Sundry Print Report

Well Name: FEDERAL EF COM Well Location: T18S / R25E / SEC 6 / County or Parish/State: EDDY /

Type of Submission: Notice of Intent

Type of Action: Plug and Abandonment

Wellbore schematics attached

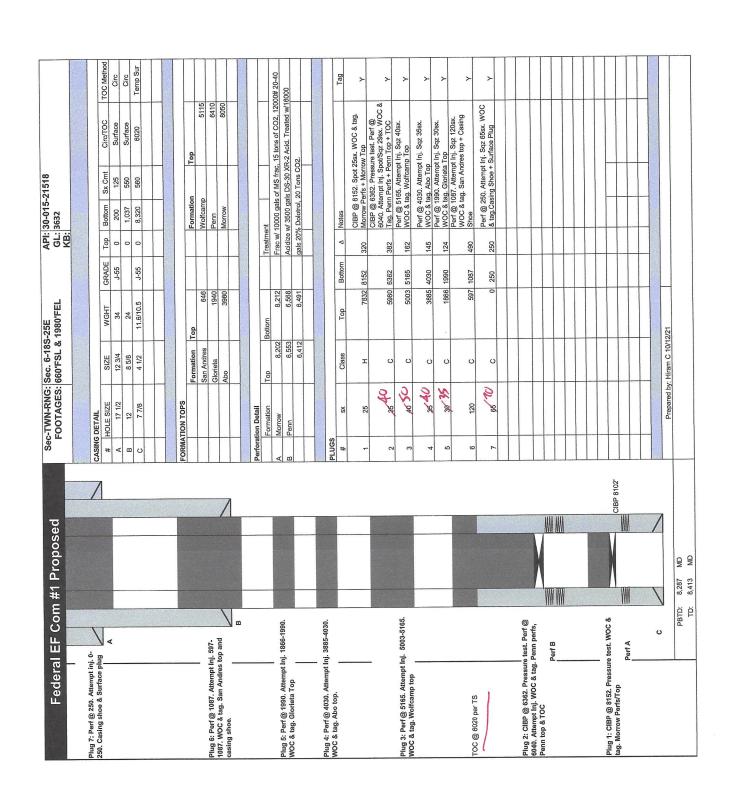
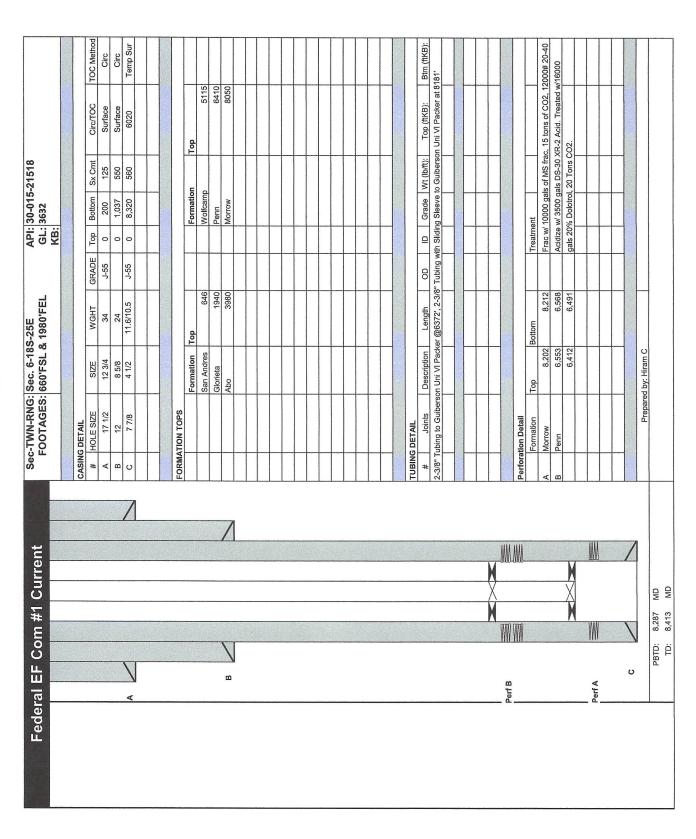
- 3. Set a CIBP at 6362' and pressure test. Perforate at 6040'. Attempt injection rate. Spot/Squeeze (6000 to 5980') Ref & spe (infort)
 C cement from 5100' with 35 sx Class C cement on top to 5980'. WOC and tag. This will cover Penn perfs and top and (6362' to 6020') spot 259x

- 4. Perforate at 5165'. Attempt injection rate. Squeeze with 40 sx Class C cement from 5165'-5003'. WOC and tag. This will cover Wolfcamp top. 50 9X (inlout)

- 5. Perforate at 4030'. Attempt injection rate. Squeeze with 35'sx Class C cement from 4030'-3885'. WOC and tag. This will cover Abo top. 409x (in/out)

- 6. Perforate at 1990'. Attempt injection rate. Squeeze with 30 sx Class C cement from 1990'-1866'. WOC and tag. This will cover Glorieta top. 35 9x (in/out)
